**THE NETWORK RAIL (OLD OAK COMMON GREAT WESTERN MAINLINE TRACK ACCESS) ORDER 202[ ] (the draft Order)**

We refer to the revised land plans you shared with the Inspector (via the Programme Officer) and us on 31 January 2024. These are: the Order Land Plan, the Redline Plan, Site Sharing Scenario 1 – Land Plan 9, Site Sharing Scenario 2 – Land Plan 10, Site Sharing Scenario 3 – Land Plan 11 and the Permanent Easement Land Plan 12 (together, the **31 January 2024 Plans**).

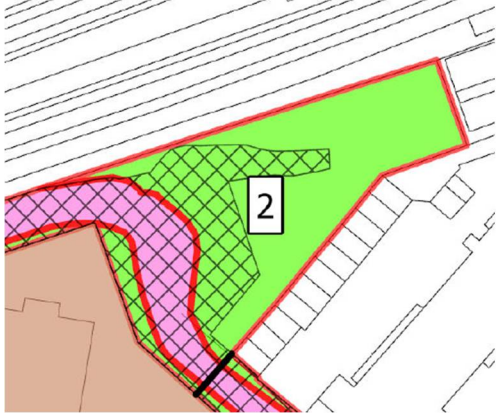
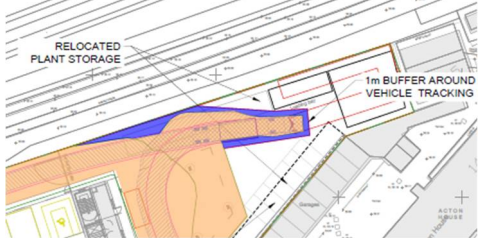
Extract from the 31 January 2024 Plans	NRF comments
<i>General comments on all the 31 January 2024 Plans</i>		
1.	<p><u>Example 1 – boundary of warehouse (extract from Land Plan 9)</u></p> 	<p>The thickness of the redline is still encroaching into the boundary of the warehouse. The same applies to the boundary around 227-237 Horn Lane, and the boundary of BPL's proposed development (see paragraph 14(a) of BPL's Additional Objection).</p> <p>This comment applies to all the 31 January 2024 Plans.</p>

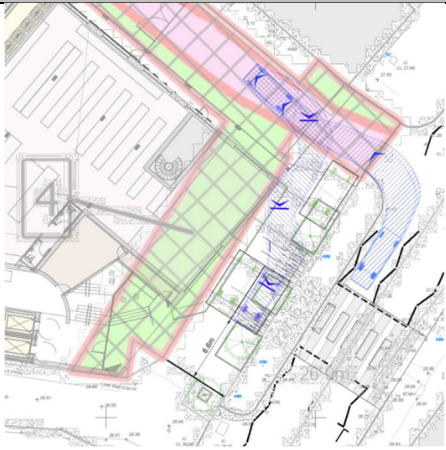
Extract from the 31 January 2024 Plans	NRF comments
	<p><u>Example 2 – boundary of 227-237 Horn Lane (extract from the Order Land Plan)</u></p> 	
2.	<p><u>Extract from Land Plan 9</u></p>  <p><u>Extract from Land Plan 10</u></p> 	<p>See our comments at paragraph 14(b) of BPL's Additional Objection. In summary, Network Rail have indicated that they require the area approximately circled in green on Land Plan 9, but they do not require the same area (also approximately circled green) on Land Plan 10. Land Plan 9 and the Order Land Plan should be revised to remove this area.</p>
